STAGE 3 SUBMITTAL - JULY 23, 2025

REVIEW COMPLETE

PROJECT DESCRIPTION  
THE PROJECT INVOLVES THE CONSTRUCTION OF NEW SIDEWALKS ON BOTH SIDES OF SPRINGDALE ROAD FROM POOLE ROAD TO YELLOWWOOD DRIVE.

PROJECT ID  
120861

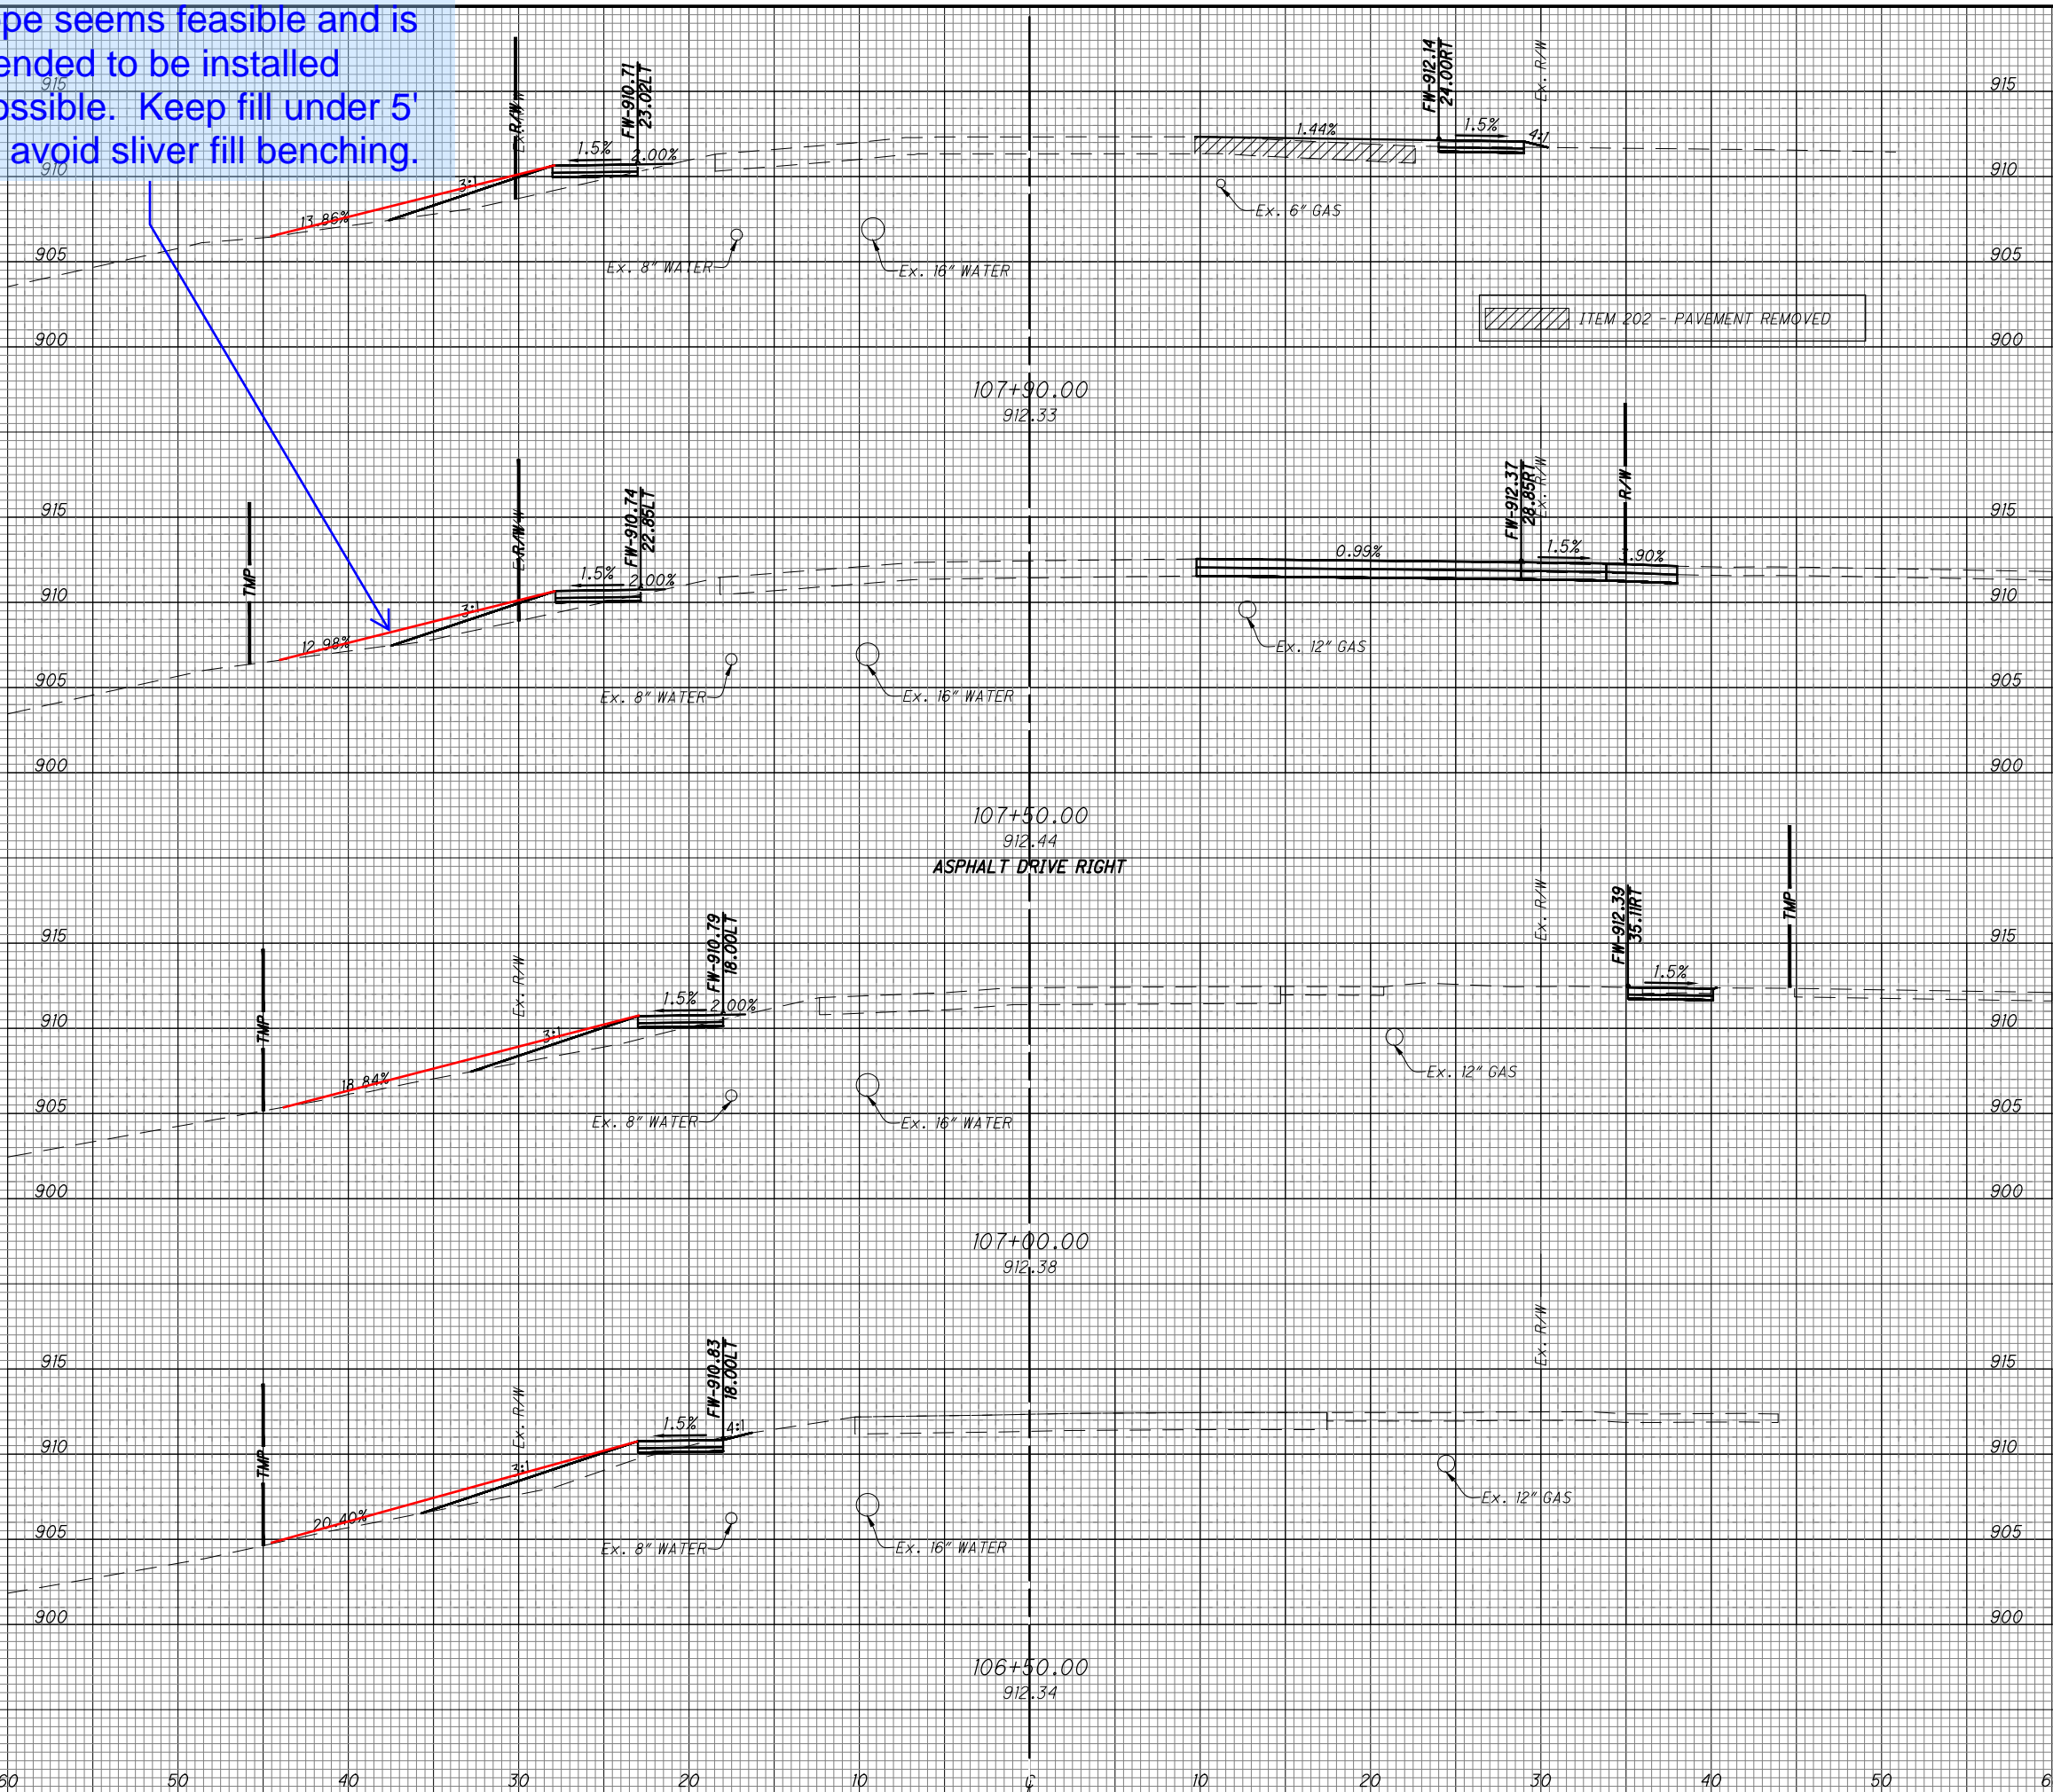
A 4:1 slope seems feasible and is recommended to be installed where possible. Keep fill under 5' high and avoid sliver fill benching.

CURB RAMP DETAILS

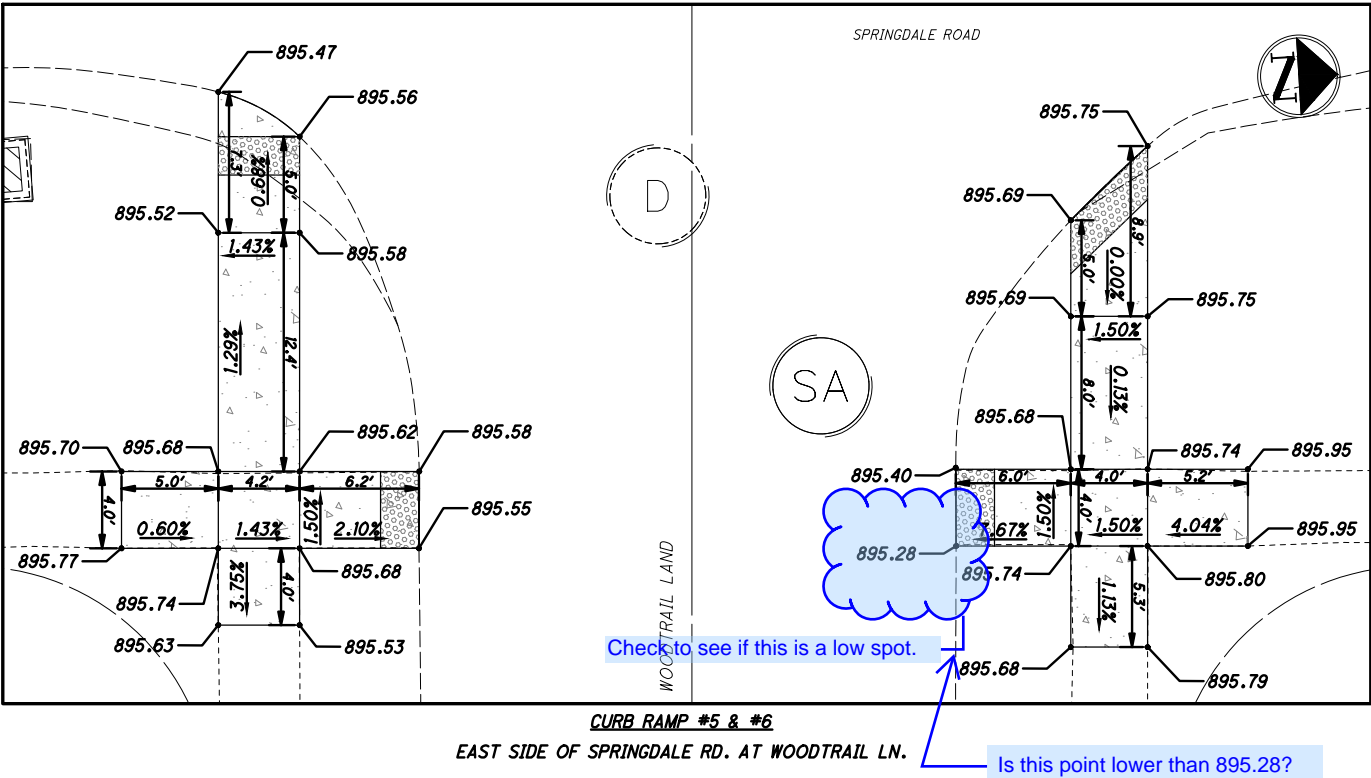
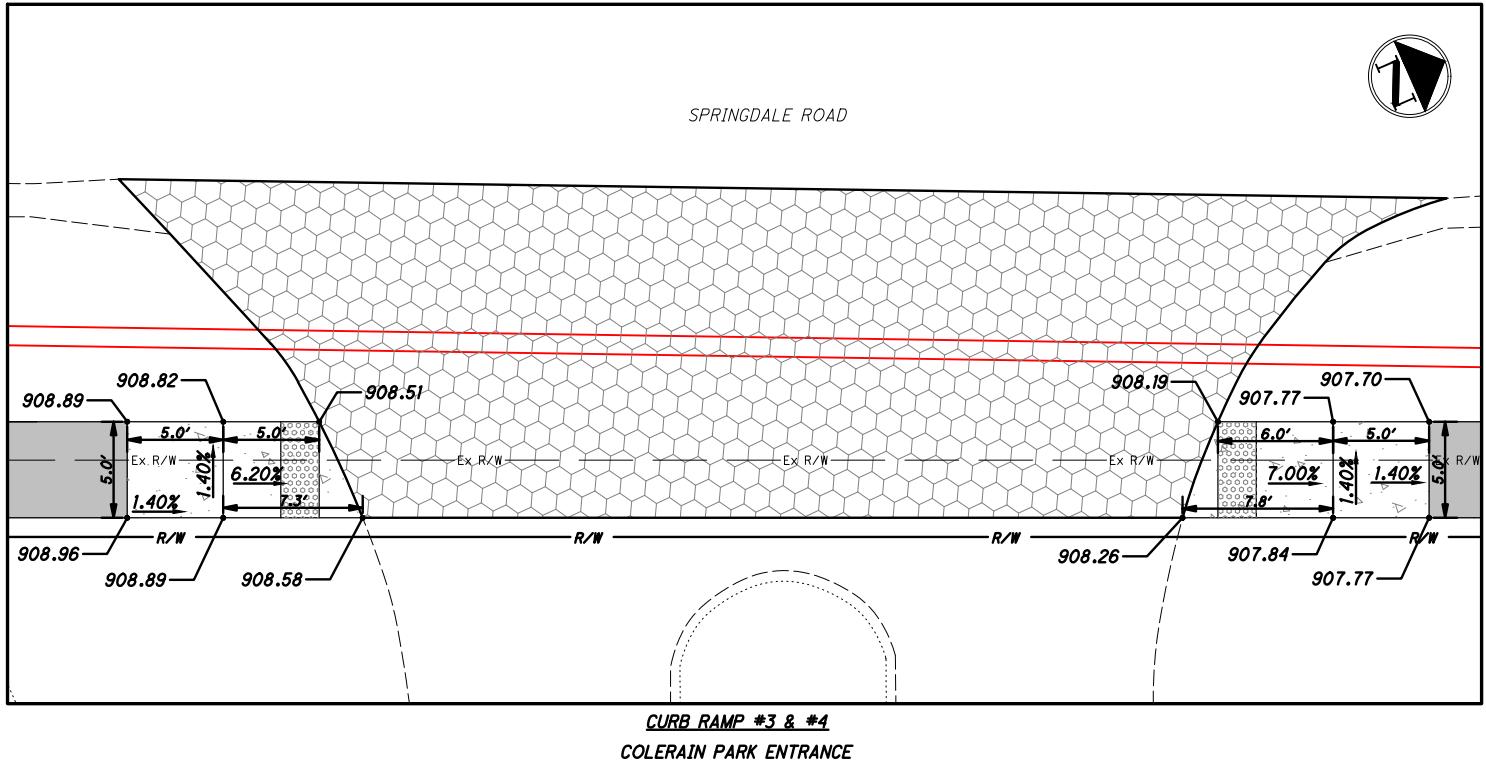
Identify curb ramp types as defined in SCD BP-7.1. Otherwise, provide pay item for Curb Ramp, APP. and add notes as shown on plan sheet 6.

CURB RAMP #9  
NW CORNER OF SPRINGDALE RD. AND DALE WOODS WAY

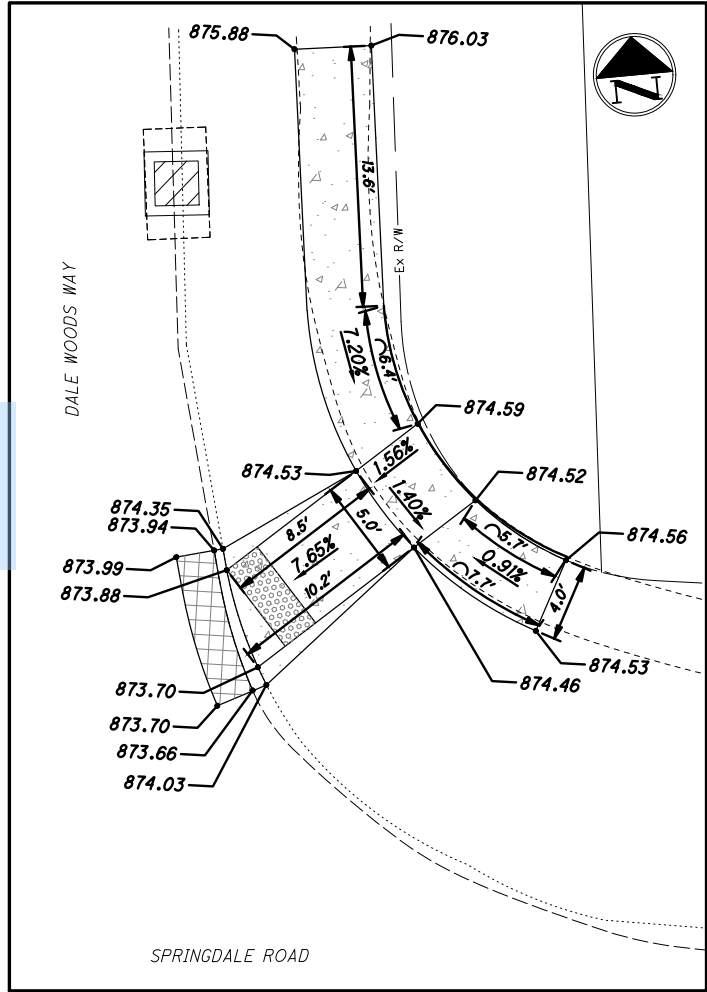
See previous  
comments on sheet  
21.

SPRINGDALE ROAD

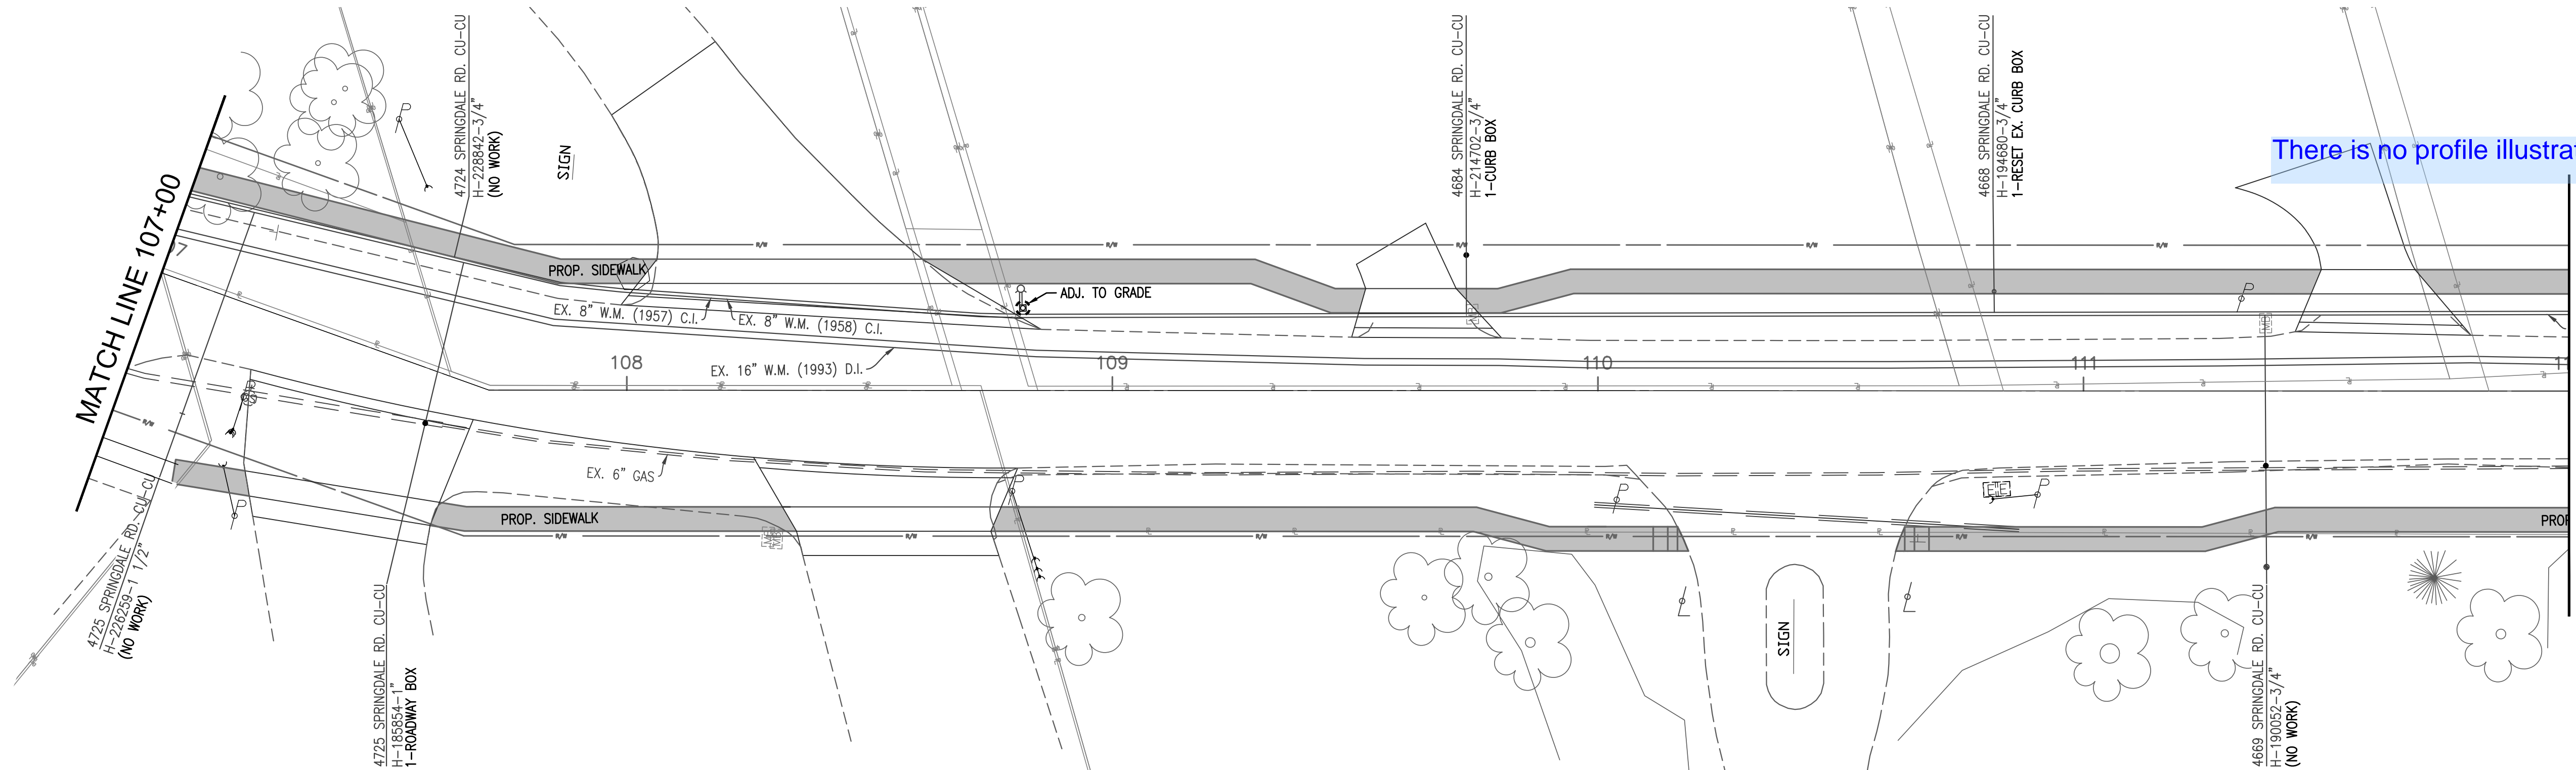
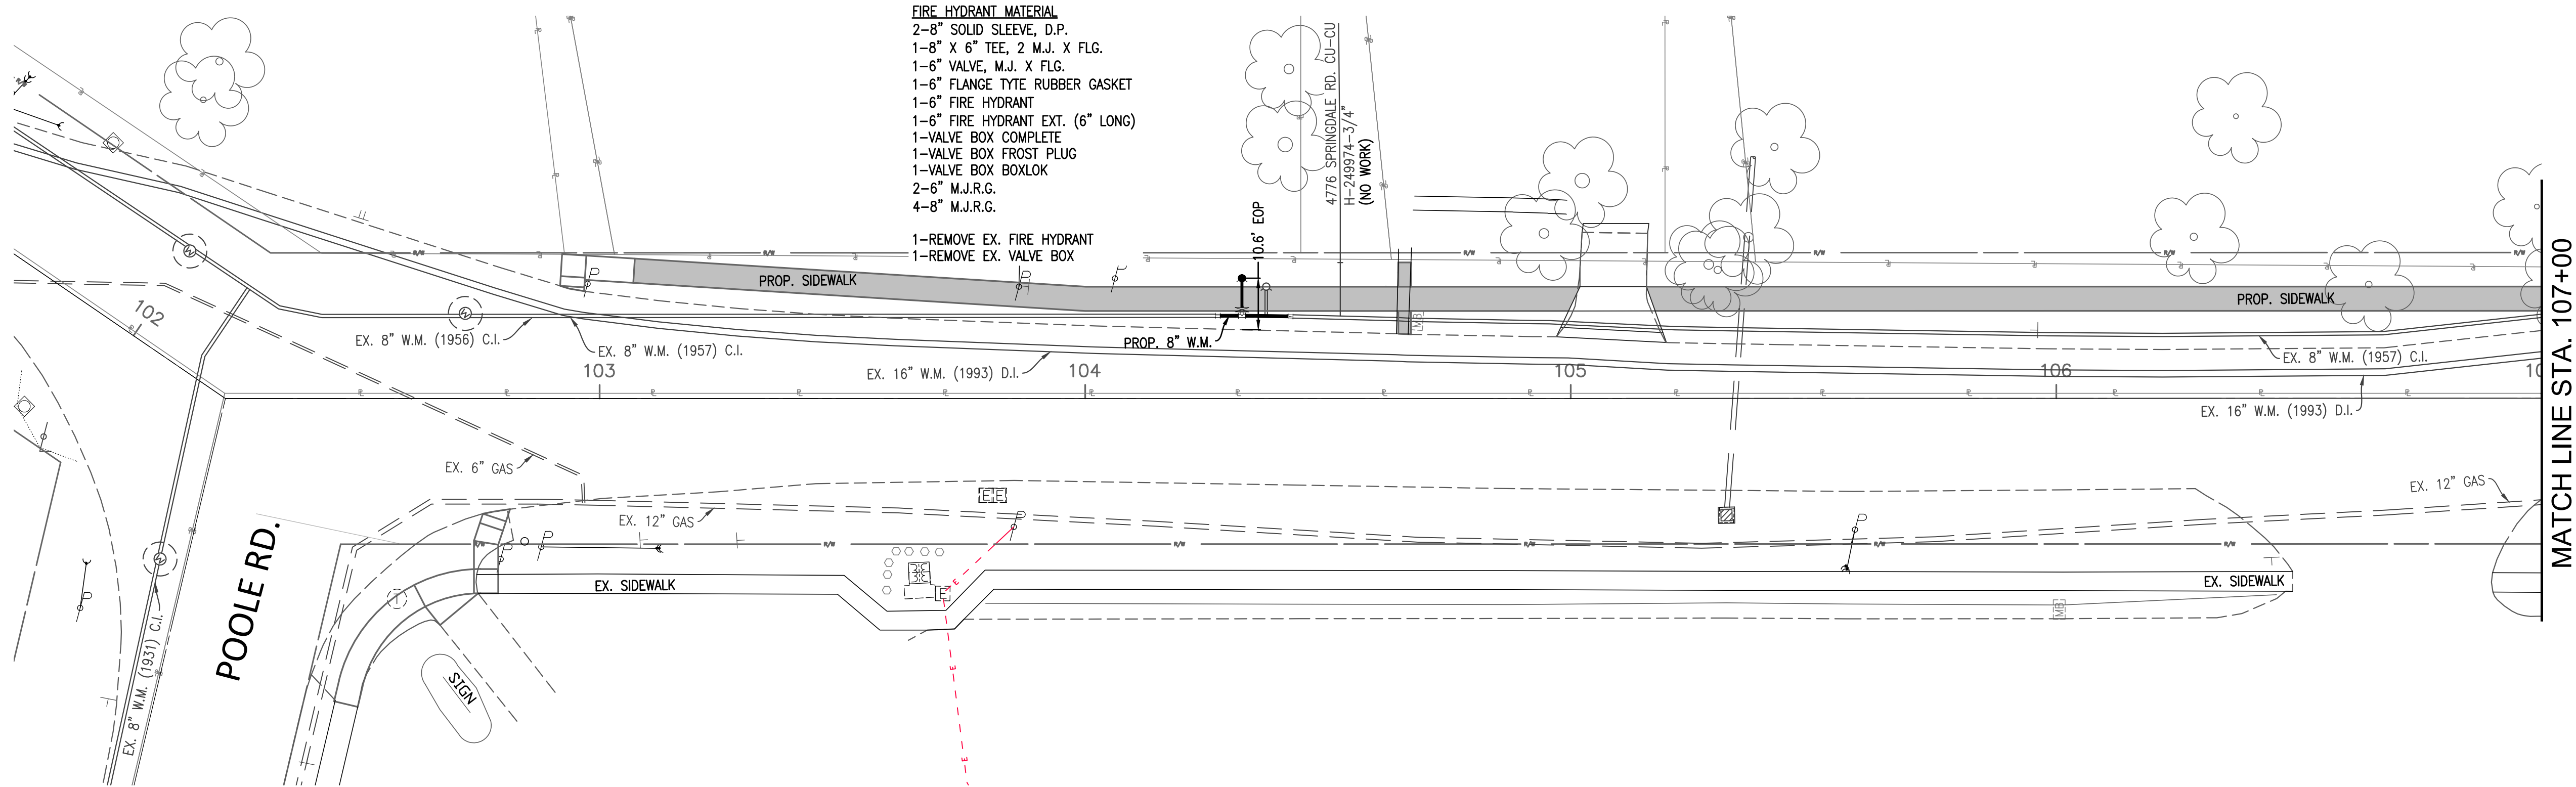
There is no profile illustrated.
